TEST SPECIFICATION: FCC part 2, §2.987 (b), part 22, §22.915(c)
COMPANY: Telrad
EUT: CET-10
DATE: September 28, 1998
RELATIVE HUMIDITY: 51%
AMBIENT TEMPERATURE: 22°C

RE: Your E-mail dated August 4, 1998; correspondence ID: 2429

Subject: FCC ID: ARACET-10, Application for type acceptance of digital radio telephone, applicant Telrad Telecommunication and Electronic Industries Ltd.
731 Confirmation Number: EA89412

3. Please find the frequency stability test data down to -30°C (corrected page 44 of Test Report TLRFCC.12663, Attachment #3, 9 plots – frequency stability, 6 plots – output power).

Attachment #1, plot No. 1

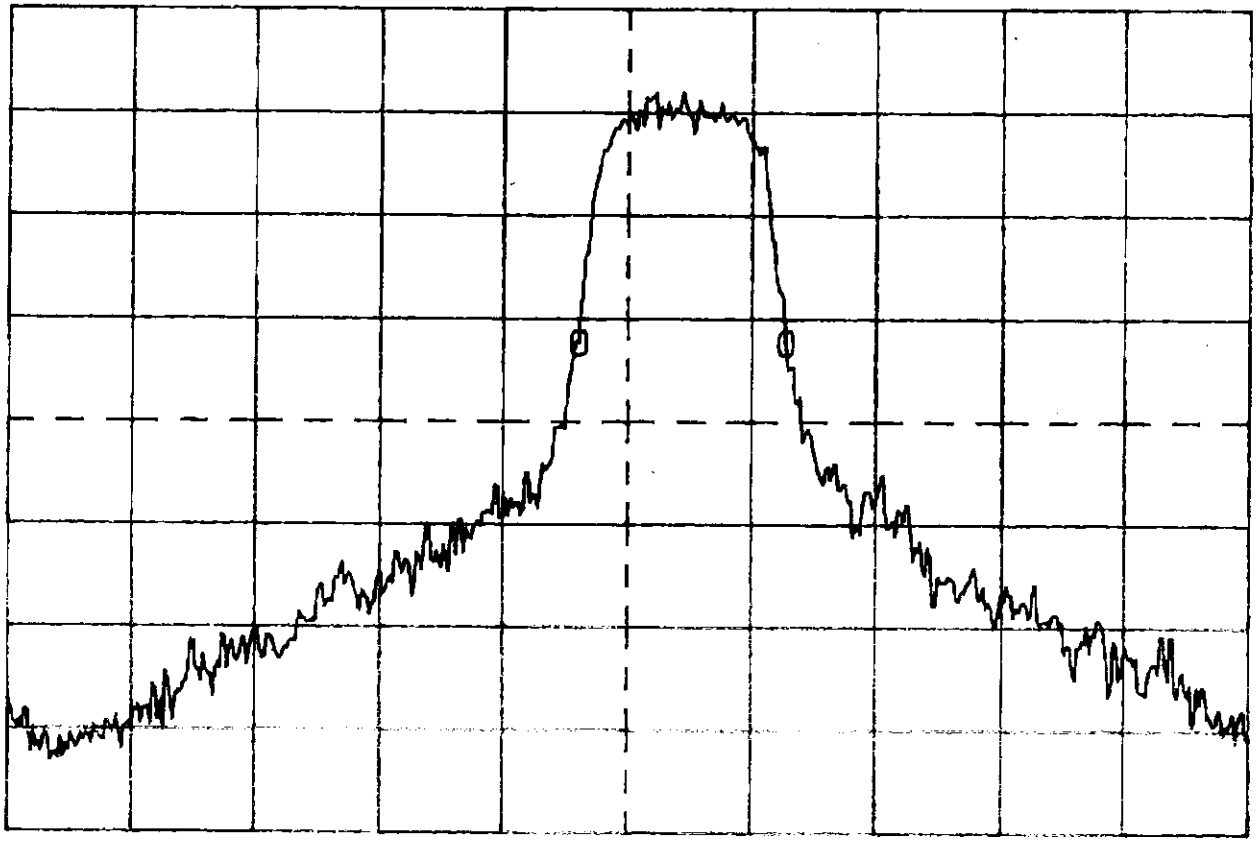
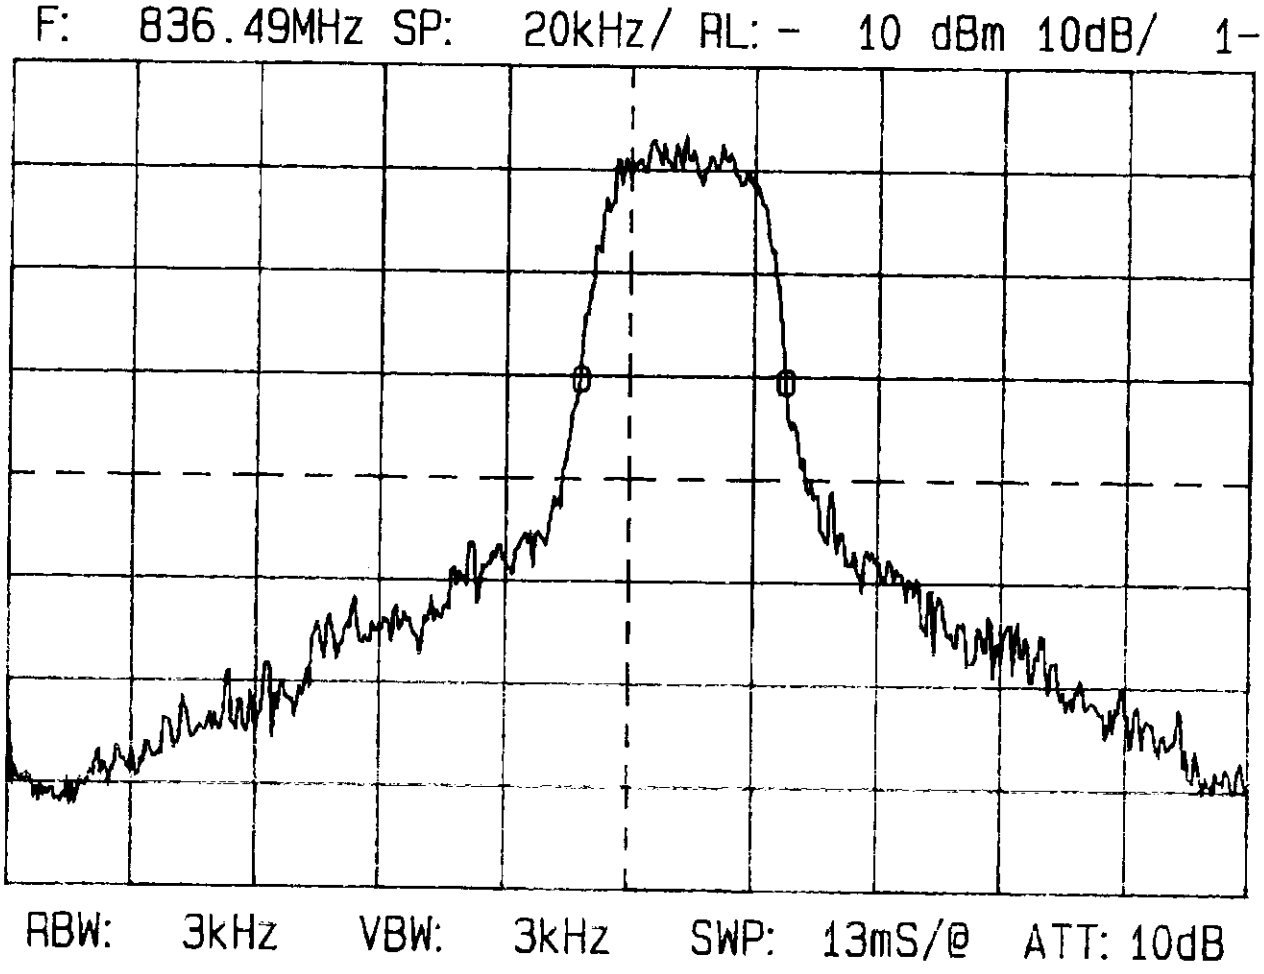
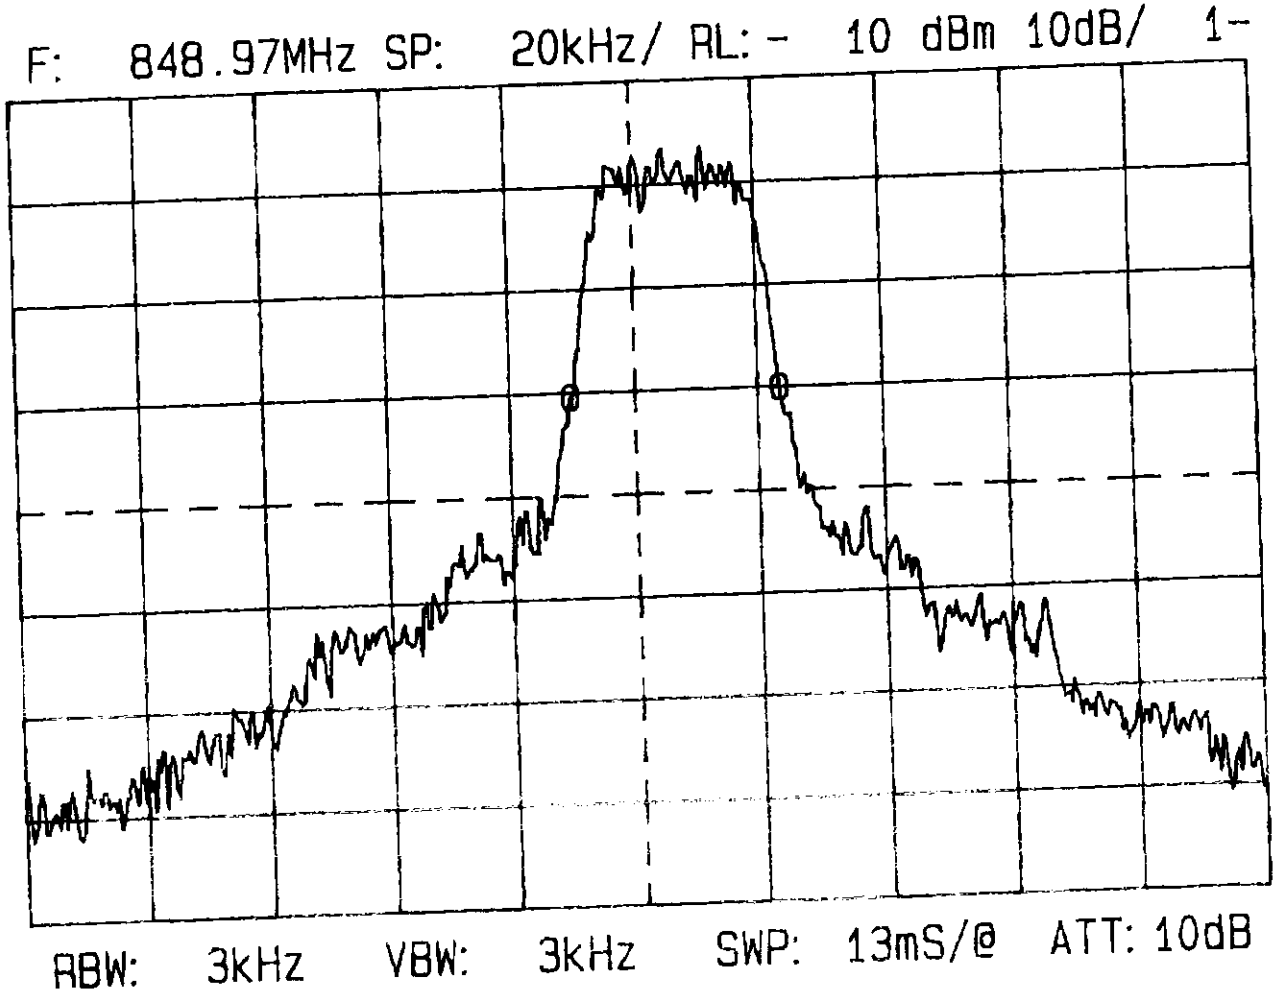
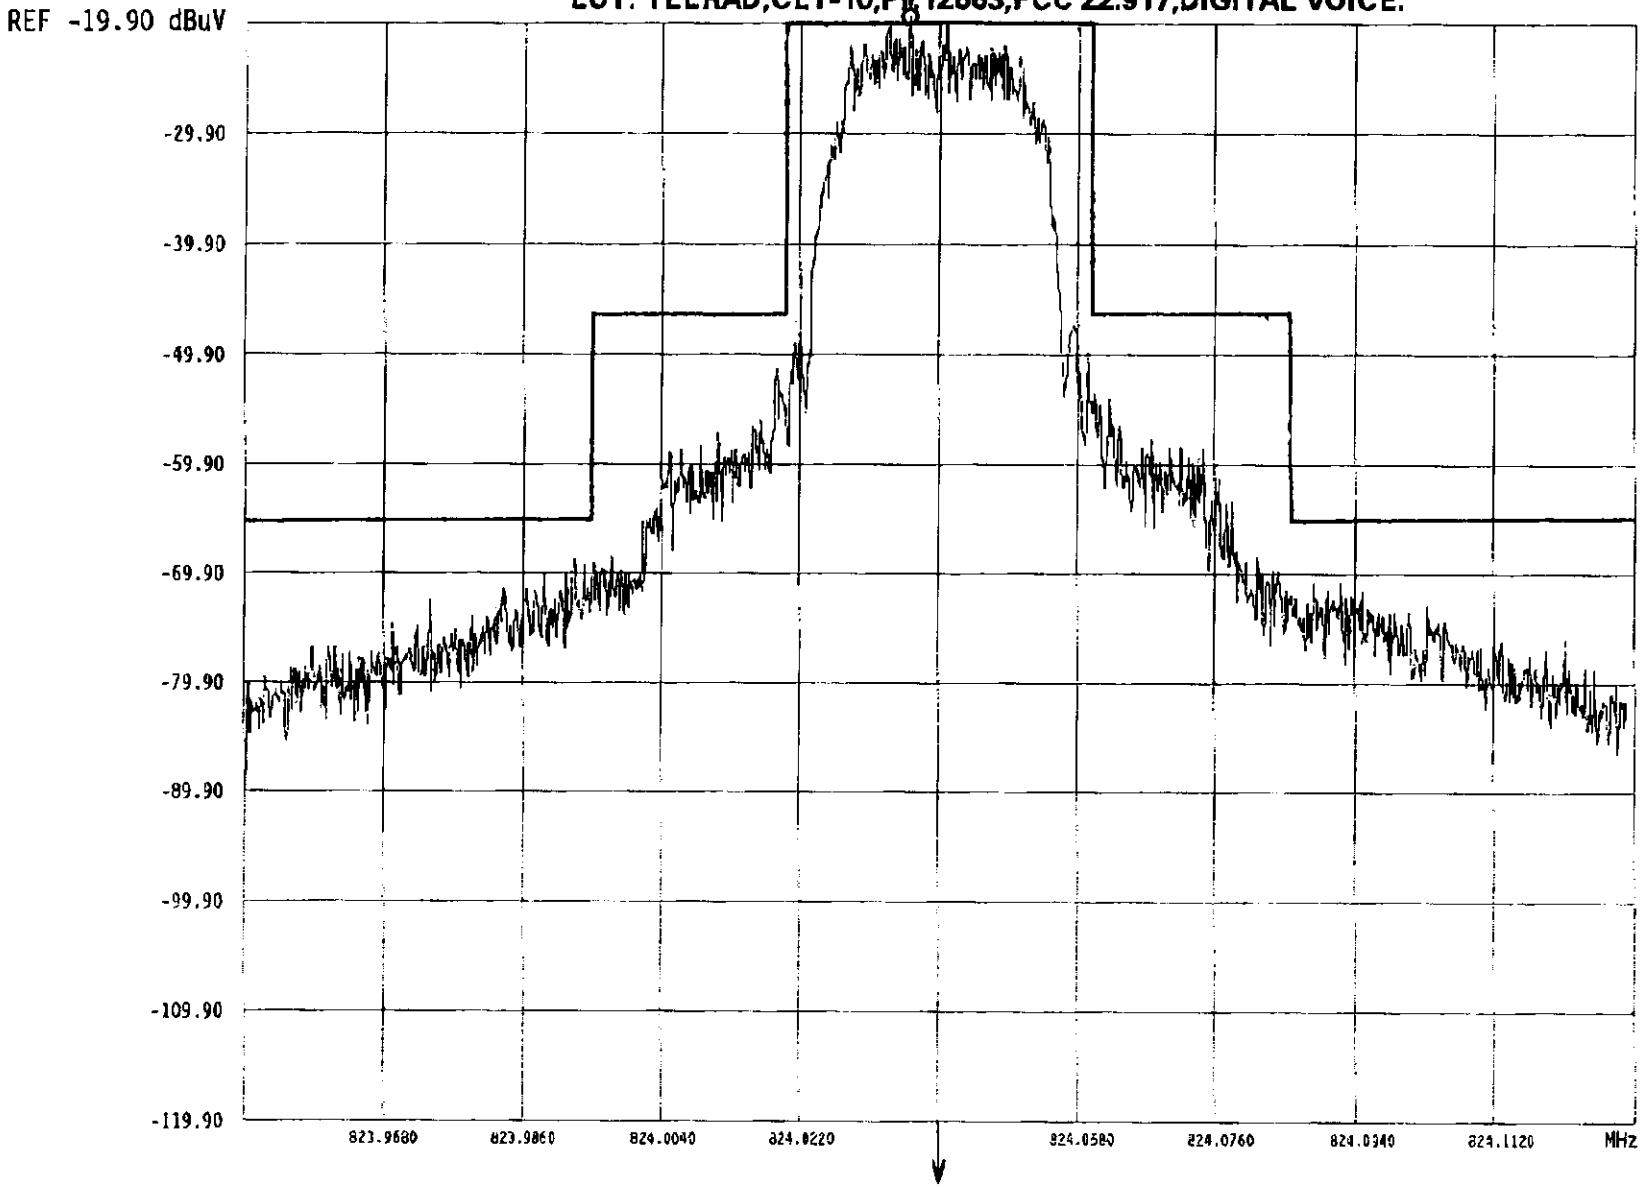
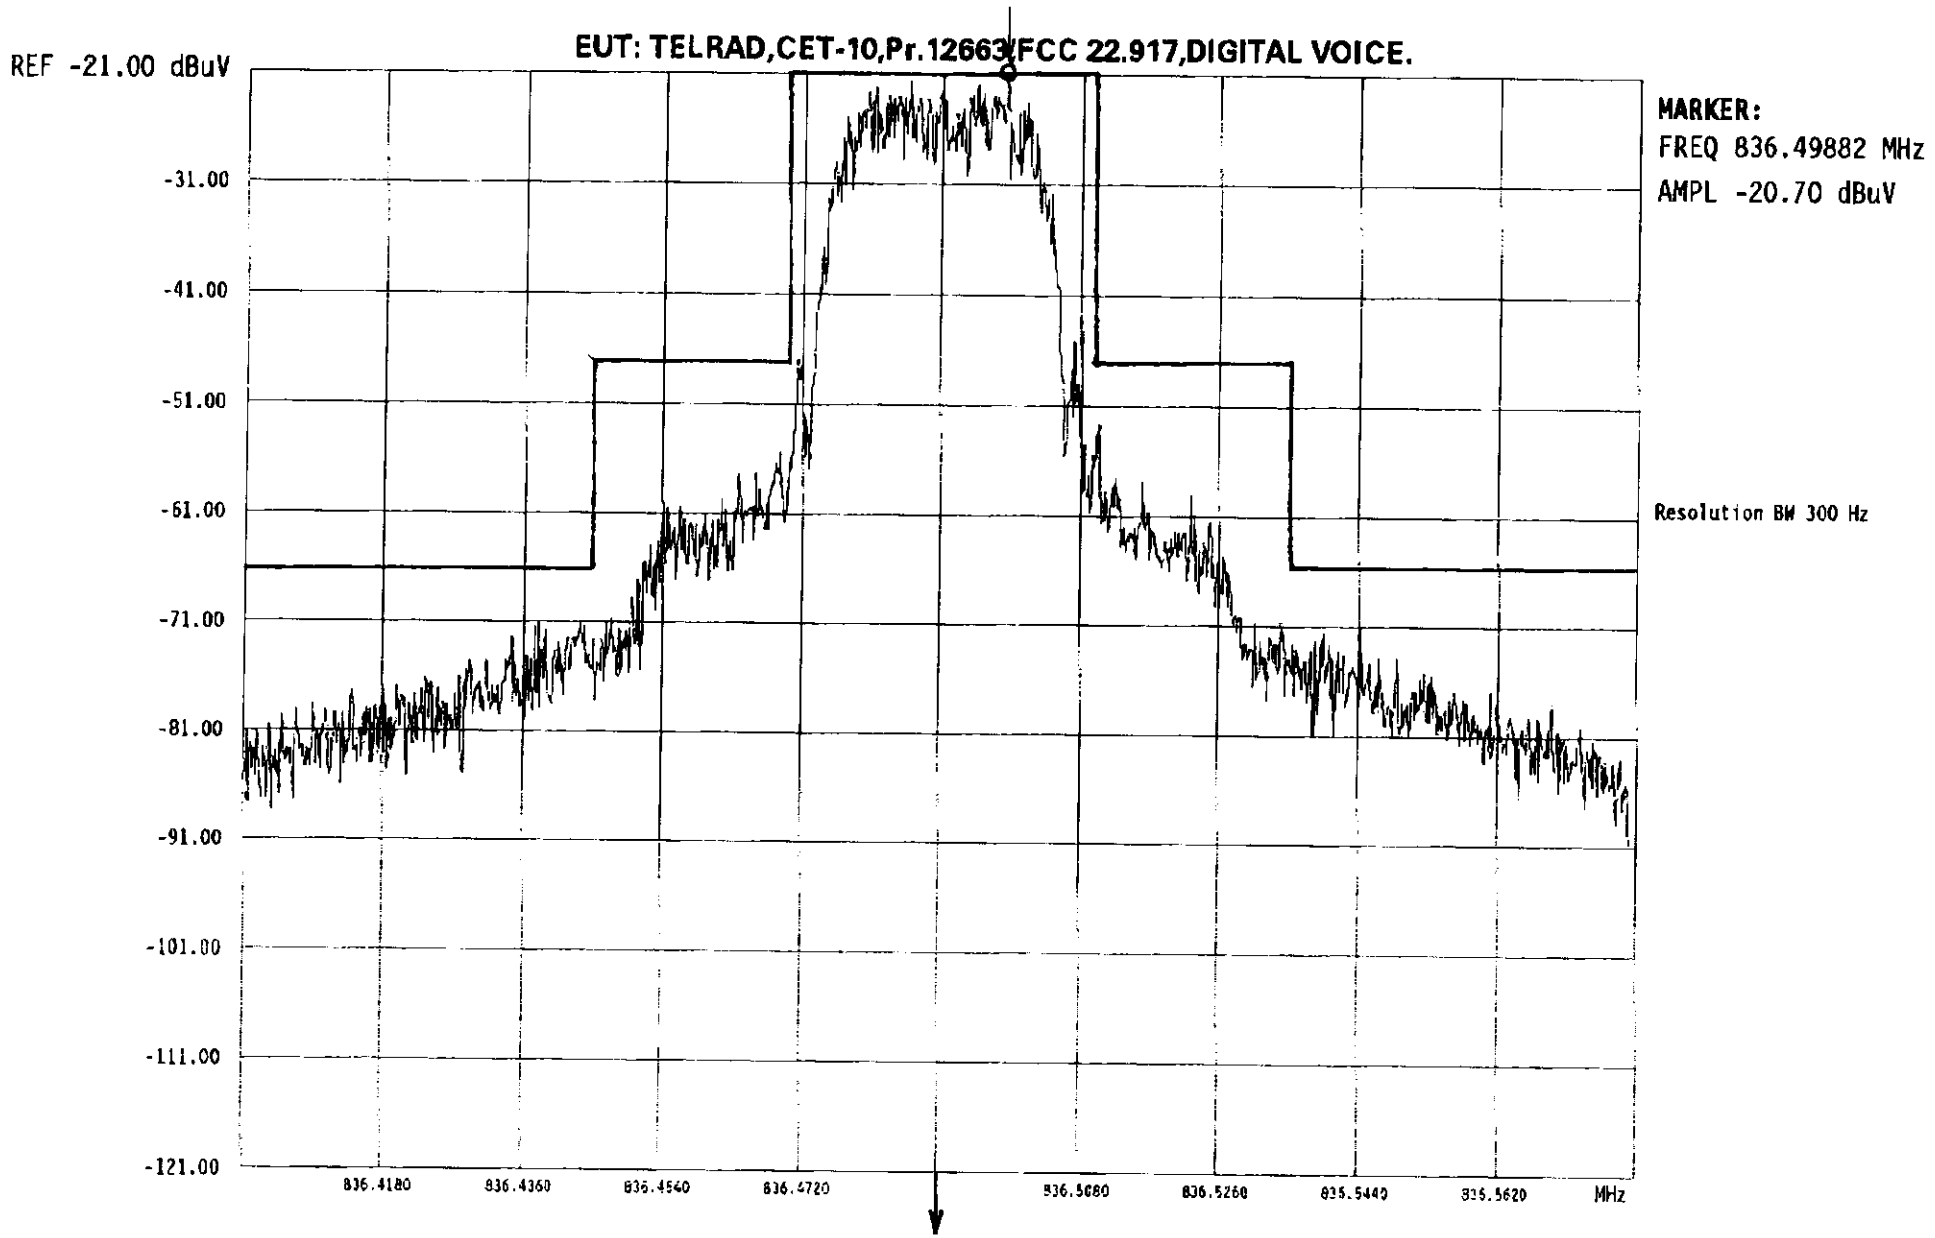
1. Please find the test results according to F1D basic characteristics (Attachment #1, 6 plots).
